STAFF REPORT
(Preliminary Plat)

CASE NUMBER: S/D 96-50 SUMMERWOOD PLACE

STAFF REPORT

STAFF REPORT
(Revised Final Plat, Preliminary Plat Approved 8/8/96)

VICINITY MAP:

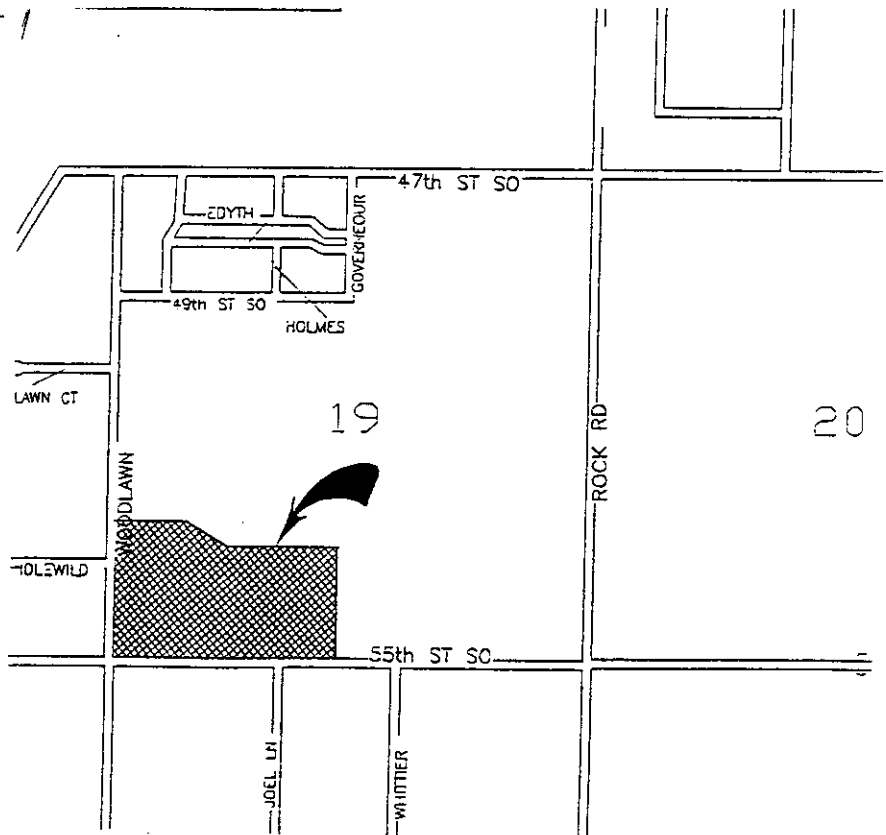
Also, Health needs to comment on the joint lagoons shown as proposed for Lots 10 and 11 and the siting of a lagoon or septic field on Lot 7. Based on the access opening requested to 55th Street and the limited lot area for Lot 7 to Summerwood, it appears Lot 7's development will be in its eastern third.

VICINITY MAP:

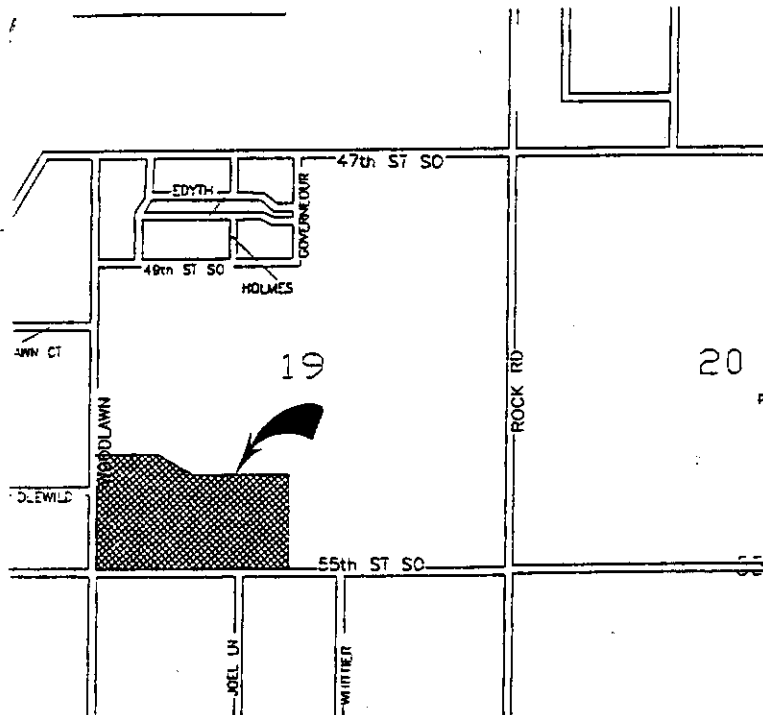
A note has subsequently been placed on the face of the plat indicating that certain lots will have restrictions on the locations of lagoons. A separate instrument specifying these restrictions will consequently be filed. Health needs to indicate if this is acceptable. Any such instrument shall also be submitted to Health for review and approval and then recording by the applicant with the recording information shown on the final plat tracing. Health also needs to comment on the concerns with a high ground water table in this area.

- L. On the final plat tracing, the MAPC signature block shall indicate John C. Frye as chairman.
- M. The final plat tracing shall clearly note what is indicated by the dashed lines along the south line of lot 3 (utility easement, building setback, etc.).

- N. The applicant's agent needs to indicate the status of easements indicated in the platting binder. Specifically, a five (5) foot easement is noted across the site's north 5-feet, and only one (1) of two (2) KG&E easements are shown on the plat.

VICINITY MAP:

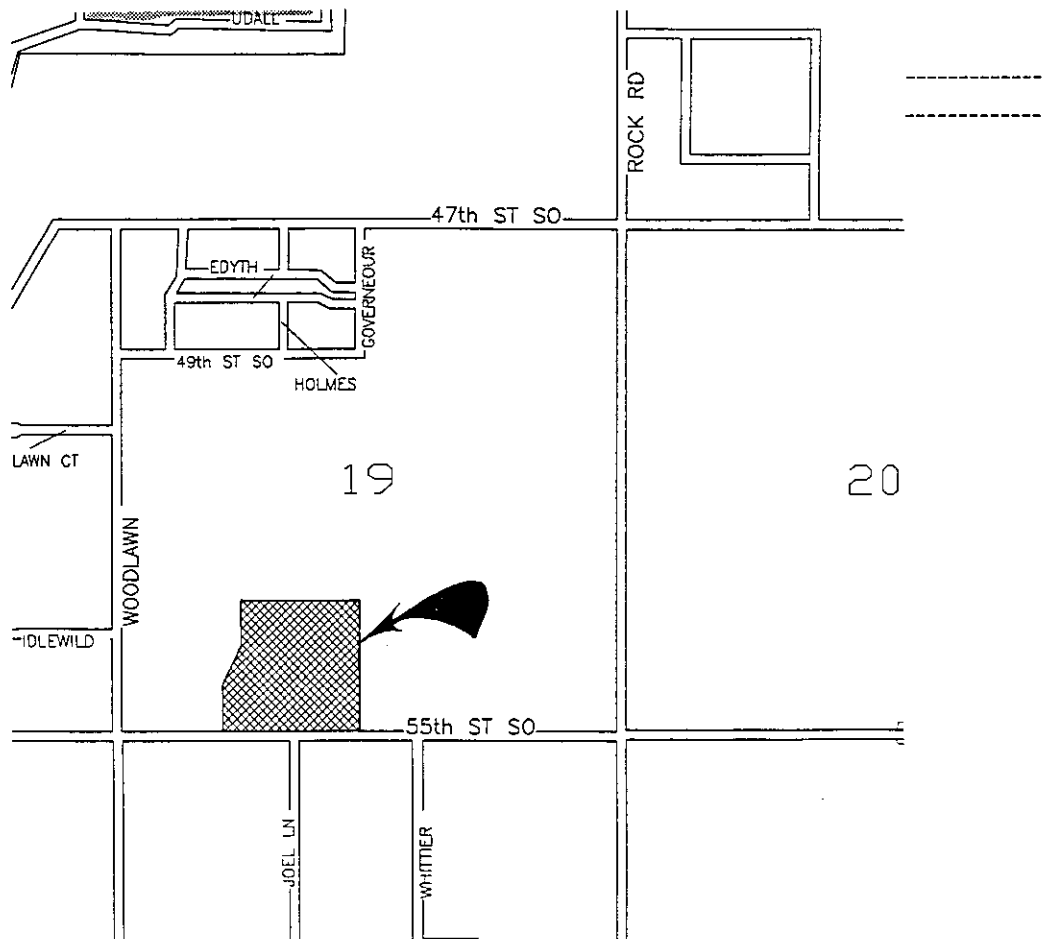
A note has subsequently been placed on the face of the plat indicating that certain lots will have restrictions on the locations of lagoons. A separate instrument specifying these restrictions will consequently be filed. Health needs to indicate if this is acceptable. Any such instrument shall also be submitted to Health for review and approval and then recording by the applicant with the recording information shown on the final plat tracing. Health also needs to comment on the concerns with a high ground water table in this area.

- J. The applicant's agent needs to indicate the status of easements indicated in the platting binder. Specifically, a five (5) foot easement is noted across the site's north 5-feet, and only one (1) of two (2) KG&E easements are shown on the plat (this was for the platting binder covering the original final plat out to Woodlawn).

VICINITY MAP:

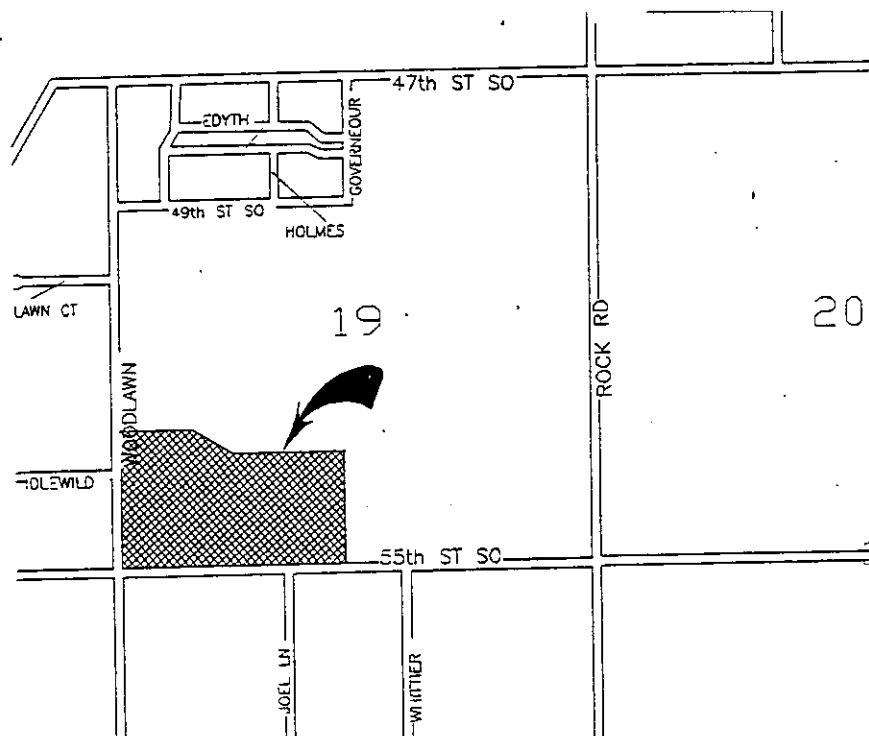
- G. The maximum depth of all residential lots shall not exceed two and one-half times the width of the lot (7-204.D). Due to the floodway crossing this site several of the proposed lots exceed the lot depth to width standard of the Regulations. Approval of this plat will indicate agreement to waive these standards.
